THE SIZEWELL C PROJECT
(EN010012)

DEADLINE 2

WRITTEN REPRESENTATION SUBMITTED BY THE HEVENINGHAM HALL ESTATE (THE HHE)
(INTERESTED PARTY NUMBER: 20026675)

Appendix 2
Yoxford Roundabout: Modelling Parameters (55m ICD, DCO Version)

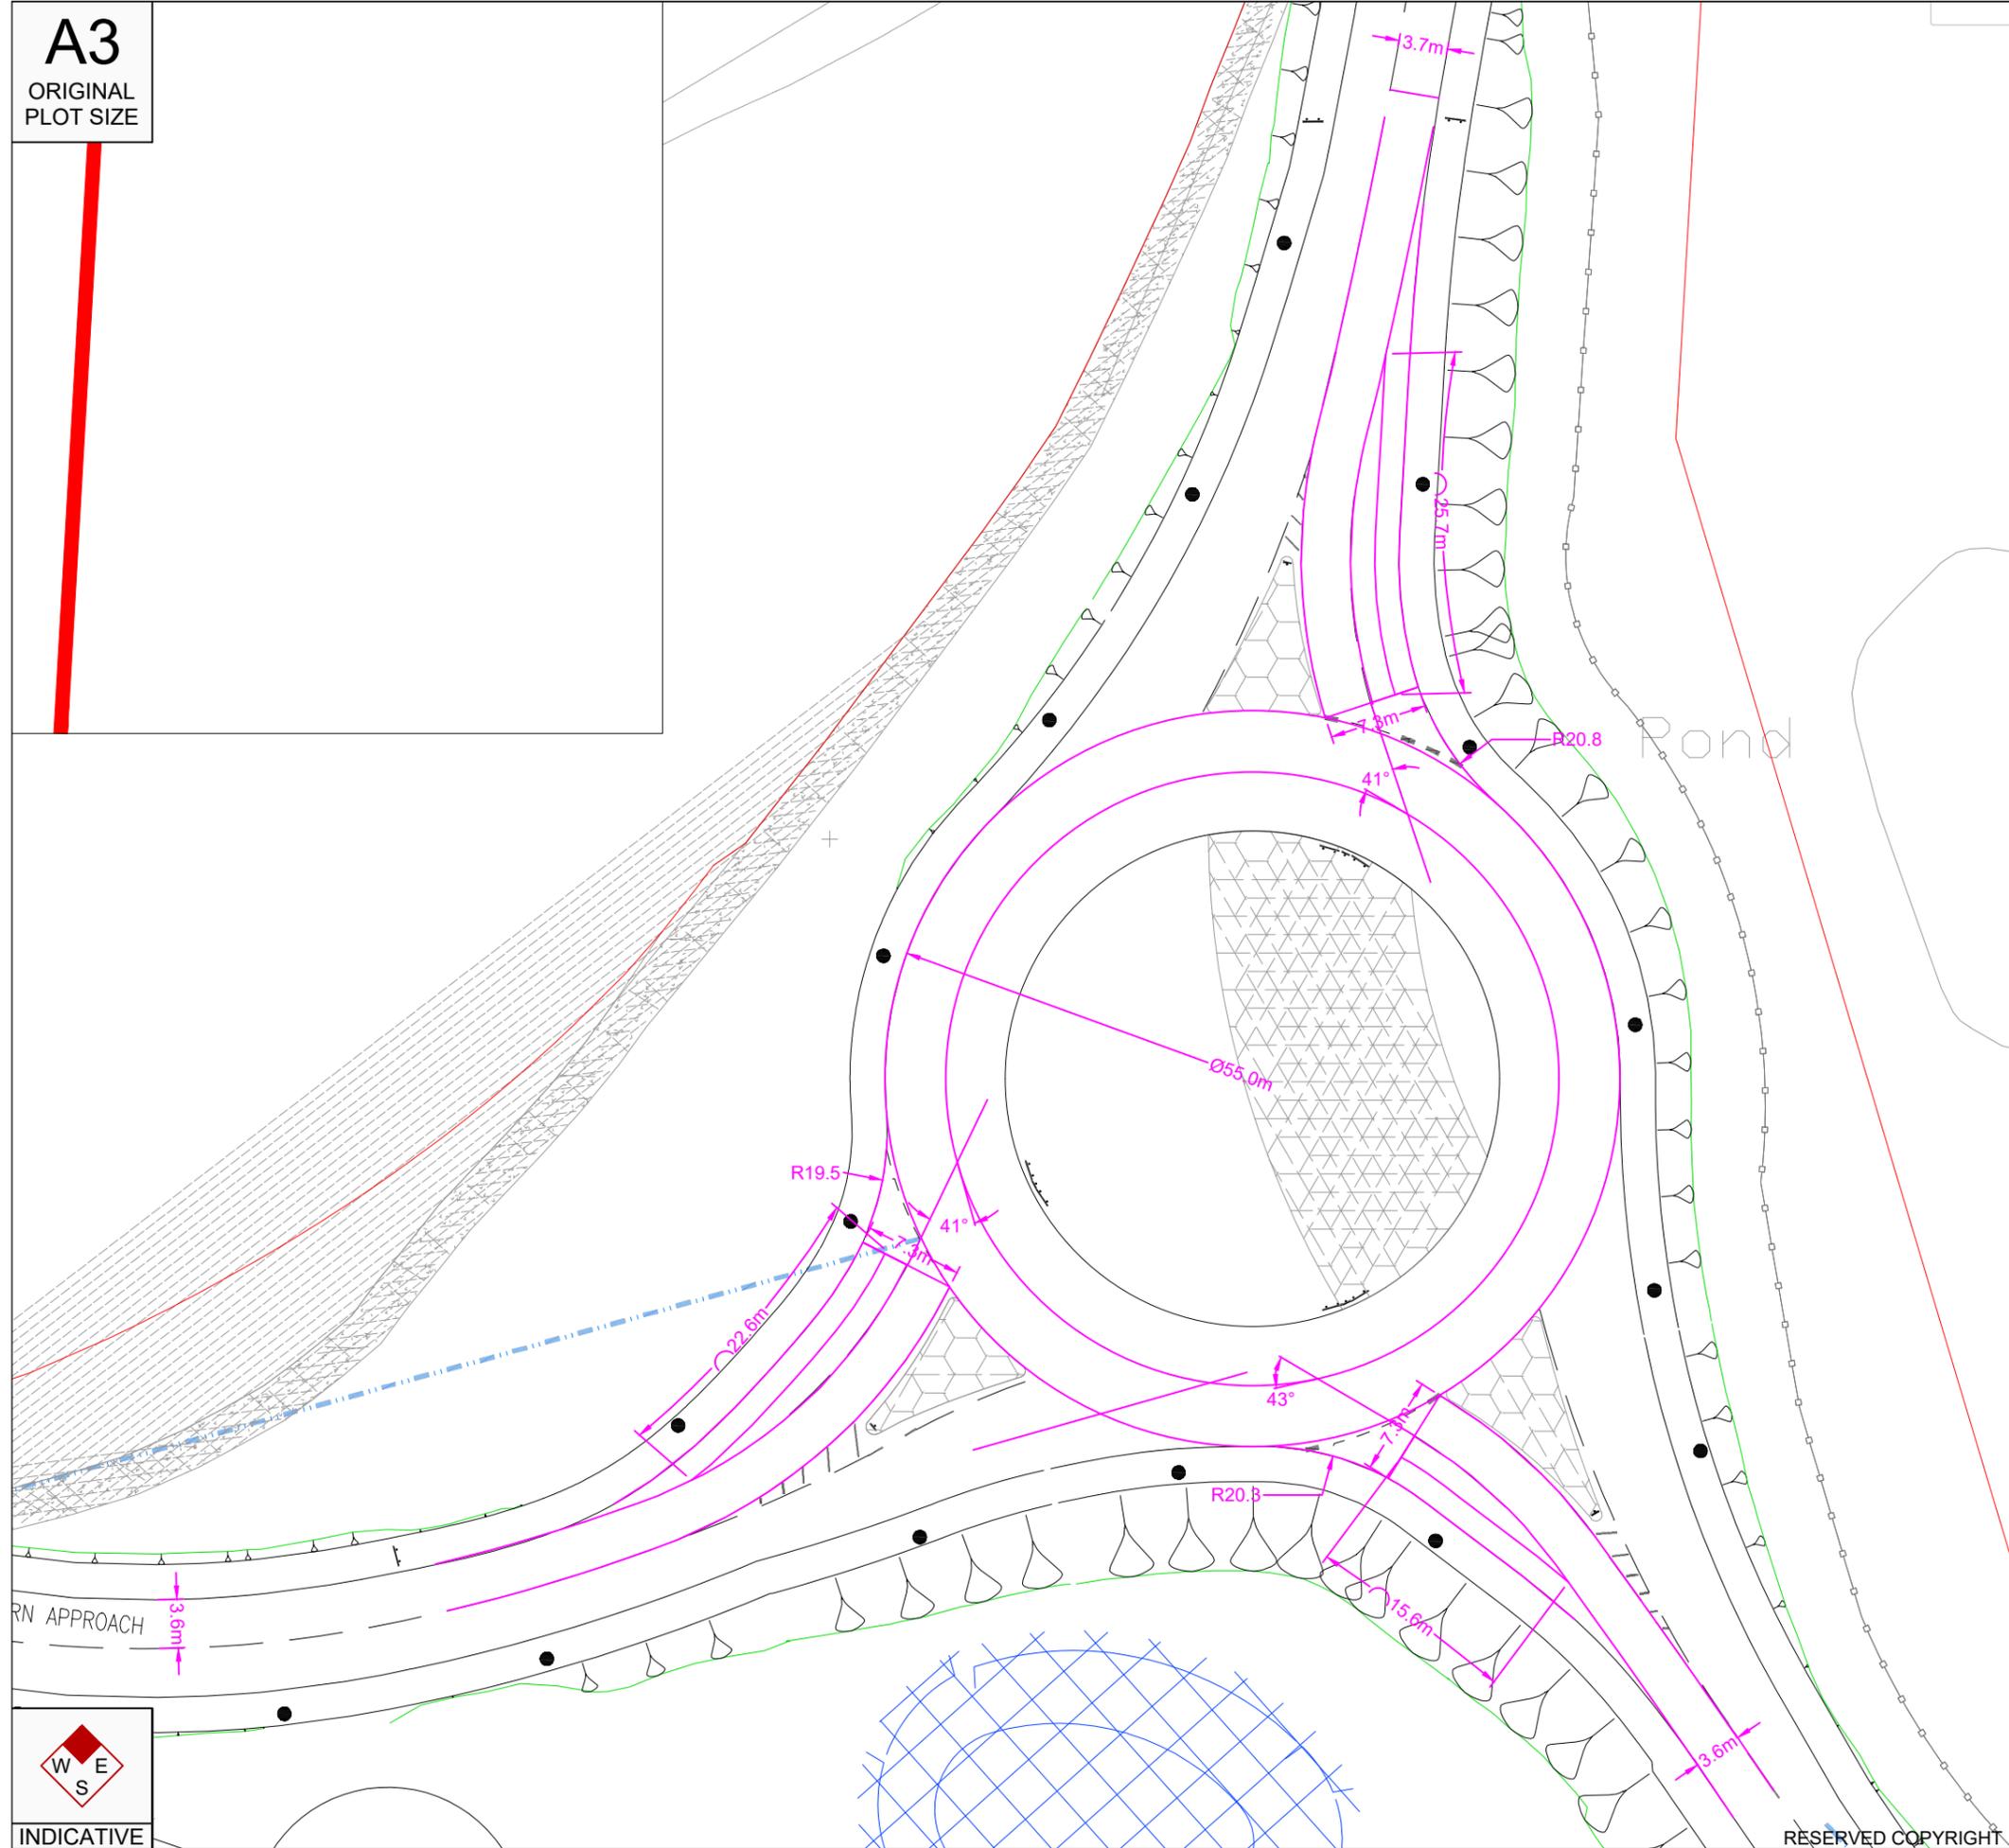
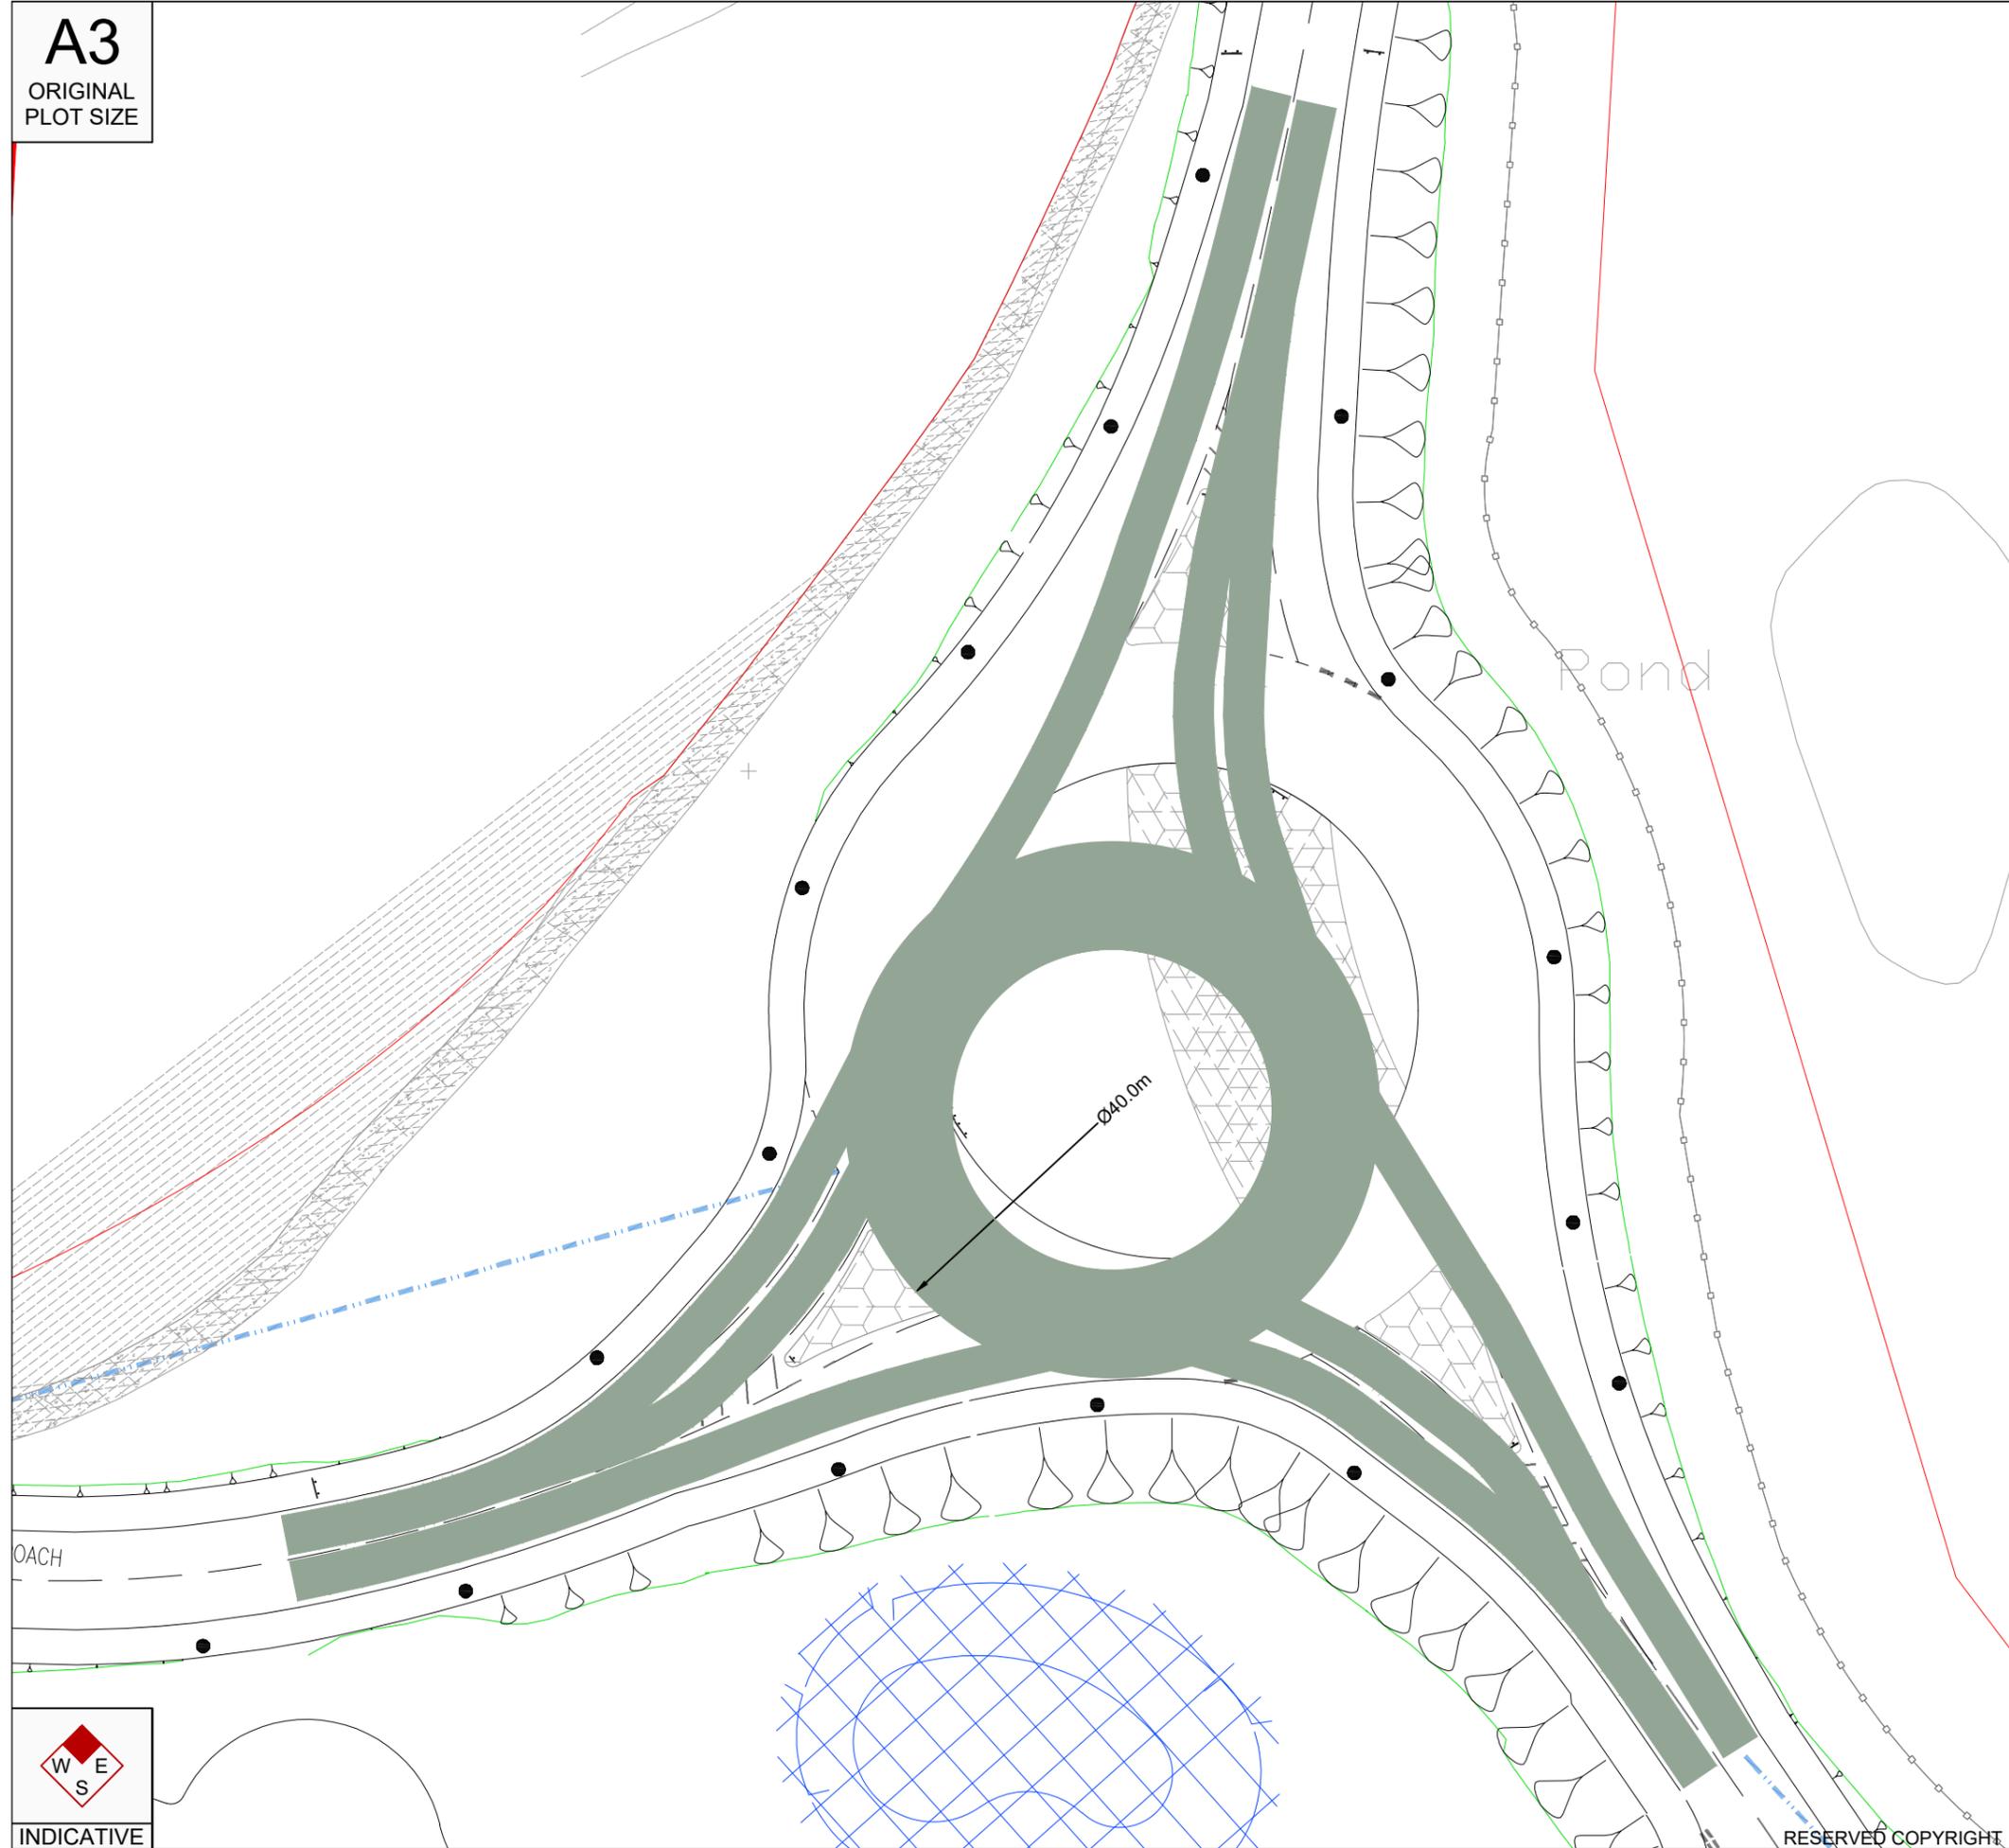
- 2.15 The Applicant therefore needs to provide some reassurance that its model can be considered reliable, as it would appear some elements (such as the modelled queues) do not match. TPA has produced a drawing (TPA ref **2009-039 MP01**, see **Appendix 2** Yoxford Roundabout: Modelling Parameters (55m ICD, DCO Version)) showing the correct measurements that should be used in the model.

Mack GU713 + Trailer
 Overall Length 27.580m
 Overall Width 2.530m
 Overall Body Height 2.670m
 Min Body Ground Clearance 0.437m
 Max Track Width 2.553m
 Lock to lock time 6.00s
 Kerb to Kerb Turning Radius 11.339m

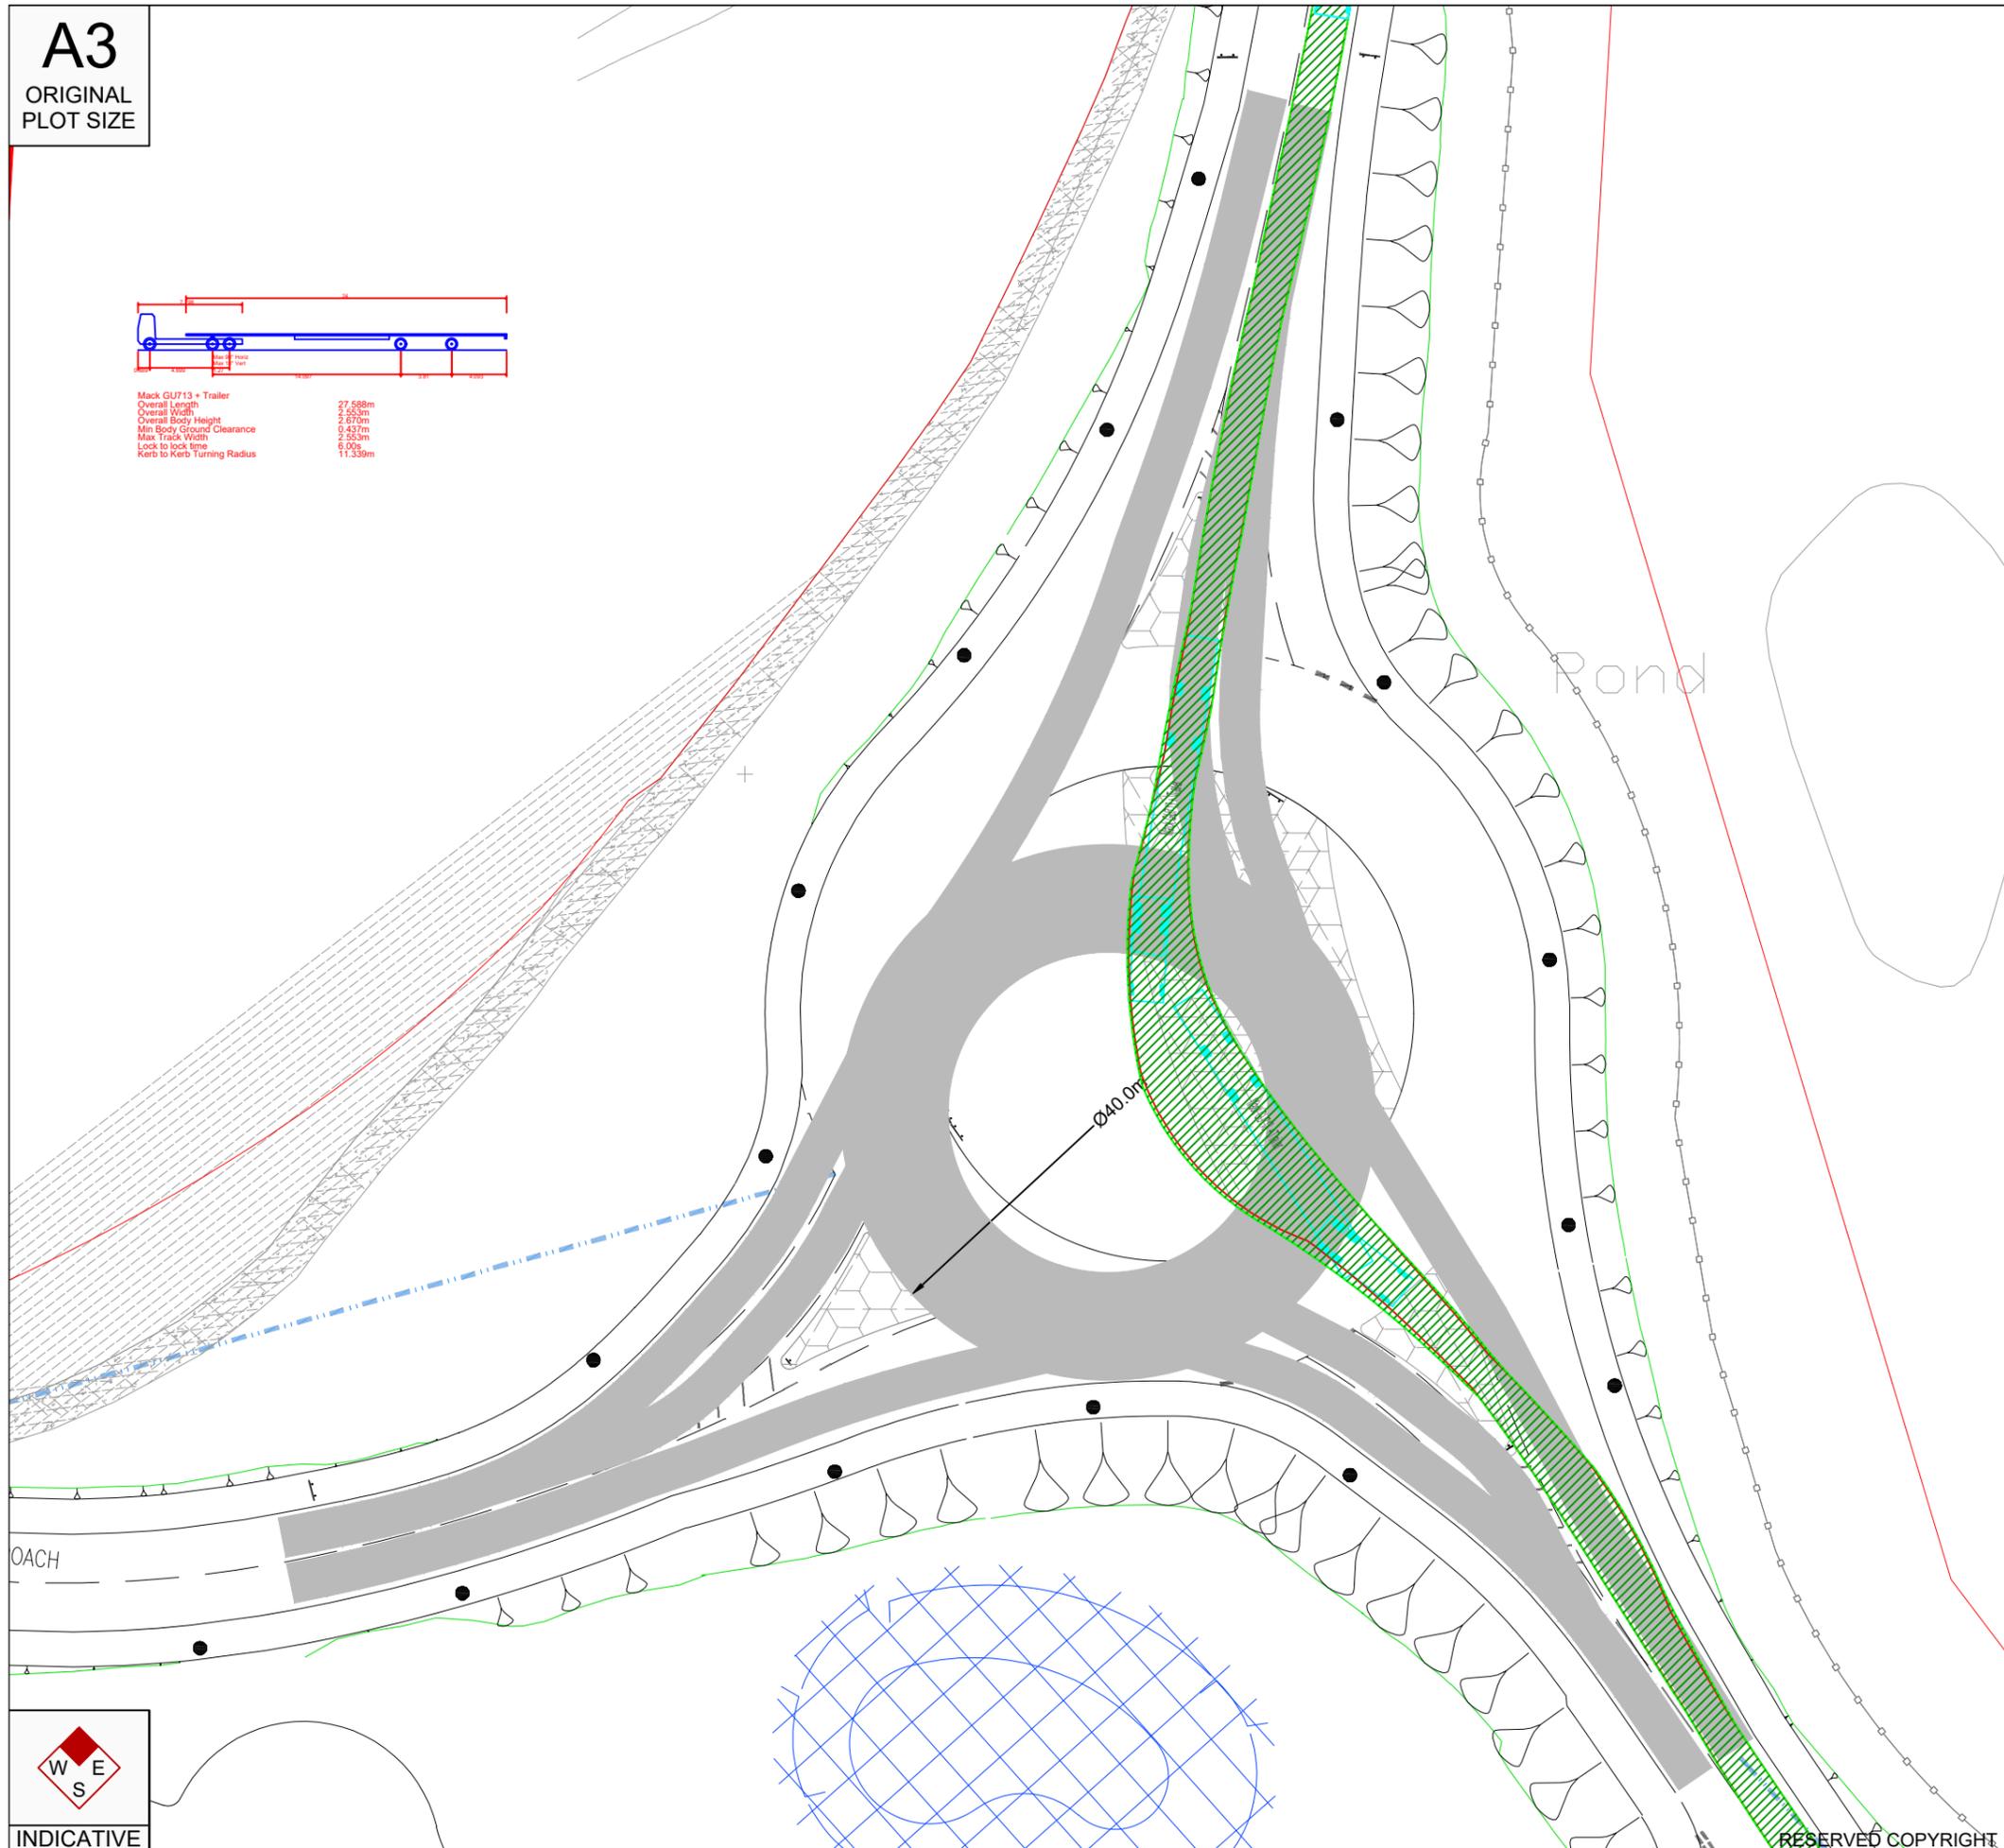
- 2.19 Noting the requirement to accommodate AIL movements too, TPA has also tested the possible swept path of a 27.6m long vehicle (drawing **2009-039 SP01**, see **Appendix 4** Yoxford

Roundabout: Swept Path of a 27.6m Long AIL Vehicle), which demonstrates that the manoeuvre is feasible (notwithstanding the illustrative nature of the drawing).
